TRANSPORT STATEMENT

Date: 7th November 2025

Project: Kings Road, Spalding - Bocca Felice Drive-Thru Coffee Shop, Car Wash and EV Charging Scheme

- 1.4 Our report has been prepared to respond to the technical comments raised by Lincolnshire County Council's Highways Officers, in response to the above-mentioned planning application. Their comments are provided in their letter in **appendix c**.

Figure 2.4: Proposed Development Layout

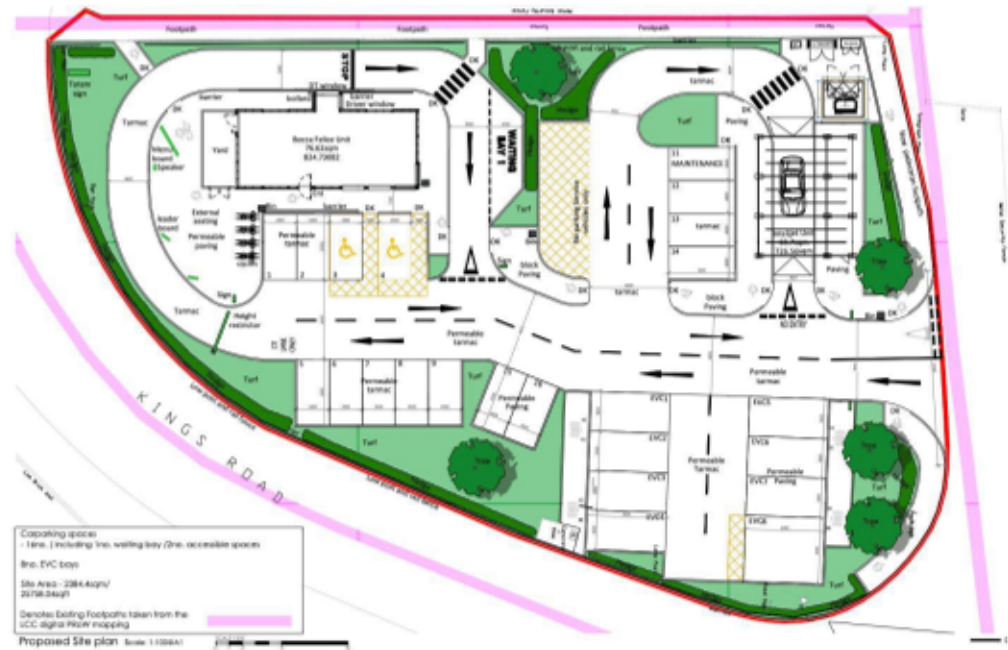
There are two Public Right of Ways in the vicinity- they need to be detailed on the proposed site plan. One goes through the site access and the build so Lincolnshire County Council Countryside object to the proposal – details have been sent to the Planner in respect of this.

The access, parking spaces, roadway dimensions are to be added to the proposed site plan.

There is no pedestrian walkway at the access - pedestrians will walk their easiest route, when accessing from the east they will use the vehicular access.

- 2.70 As shown on plan, the Public Footpath running along the western boundary of the site is maintained, and with this being a formal, surfaced route offers direct access to the development site. The development proposals show two new pedestrian links to this PROW, connecting directly into the Bocca Felice facility. To confirm, no changes to this PROW network are proposed.

- 2.72 The development layout does propose a new 2m wide pedestrian footway on the southern side of this cul-de-sac link, linking with the existing pedestrian/cycle route along the western boundary of the site. This new footway will be available for the general public to use, as well as pedestrians wanting to access the development from Kings Road to the east.

- 2.74 The project architect has added the access, parking space and road dimensions to the revised scheme drawing, which is provided in **appendix b**.

Figure 2.5: Typical Bocca Felice Service Vehicle (Small Rigid Vehicle)

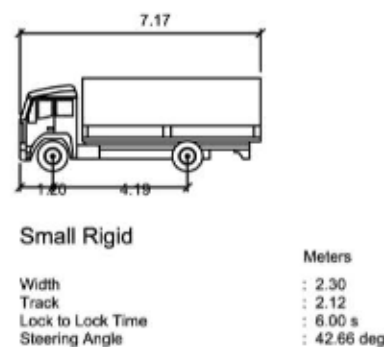
A Servicing plan is required.

- 2.62 As set out earlier in this report the Bocca Felice operator has confirmed that the facility will be serviced by a small rigid vehicle. The specification of this vehicle is presented in **figure 2.5**.
- 2.63 Typically this size of vehicle will need to visit the site every other day, to deliver to the Bocca site. As shown on the development layout in **appendix b** a dedicated service vehicle area will be provided, that can be accessed at any time of the day/night.
- 2.64 Servicing for the tunnel car wash and EV charging area will be minimal, and limited to maintenance only. A dedicated maintenance parking space is shown adjacent to the tunnel car wash, for these visits, when required.
